Document ID: IK1600217
Revision: 0
Created: 6/9/2015
Last Modified: 6/15/2015
Author: Alex Buzgau

Title: ProStar Grille/Bug Screen Rubbing Against A/C Condenser

Applies To: ProStar with Truck Build dates between 9/28/2009 and 10/1/2014

Figure 1: Grille with clip callout

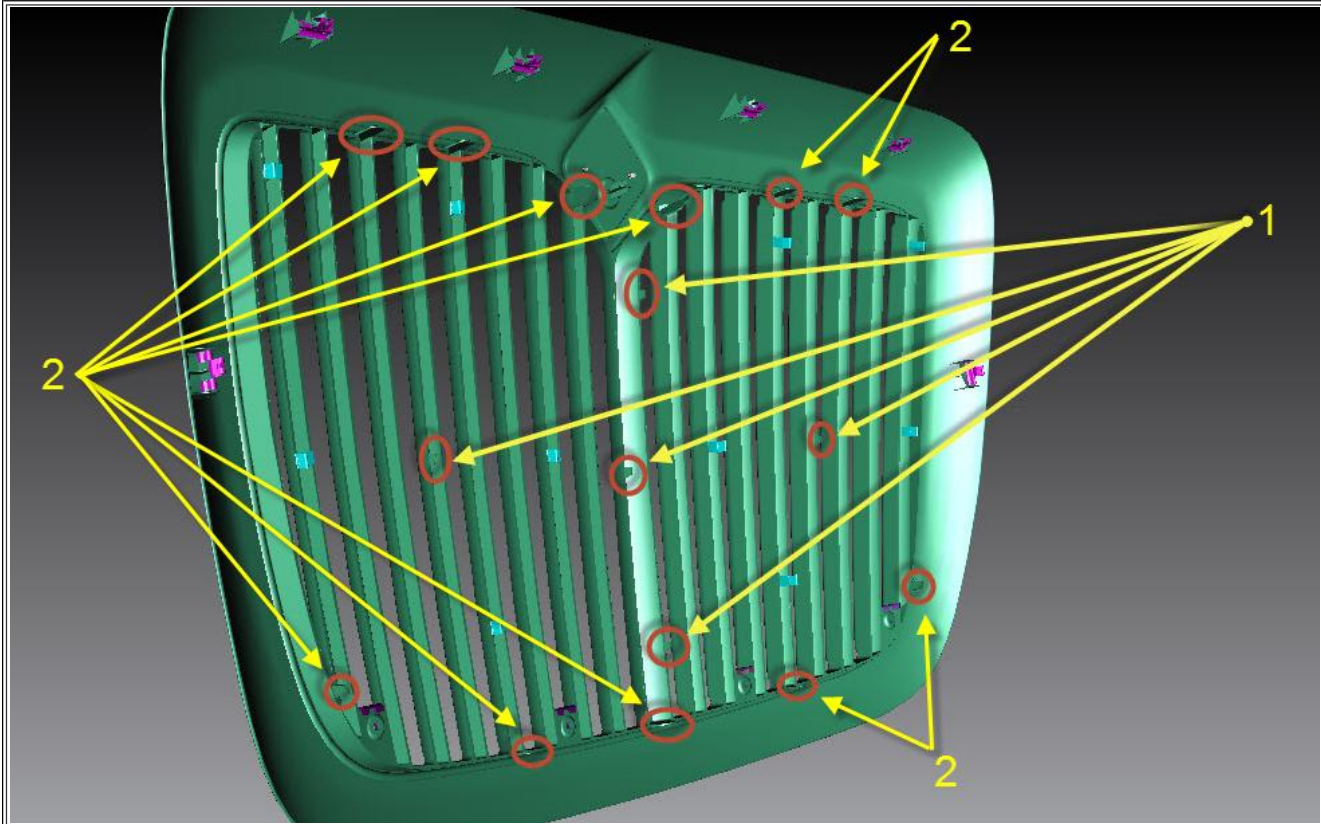
The mounting clips on the ProStar bug screen can fall off and, in some cases, cause damage to the A/C condenser (bug screen contact during high winds and/or highway use). Additional clips should be added to the grille, in the specified locations, and the bug screen should be replaced as necessary.

1. Add additional clips to the 5 mounting tabs with missing clips (see Figure 1 showing clip locations). Replace bug screen if bent or broken.
2. If the A/C condenser is damaged/punctured and it causes the A/C system to be inoperable, follow instructions for removal/replacement in the **9900, PayStar, ProStar, TranStar, WorkStar Heavy Duty (HD) Radiator / Cooling System Service Manual** ([0000628059](#)).
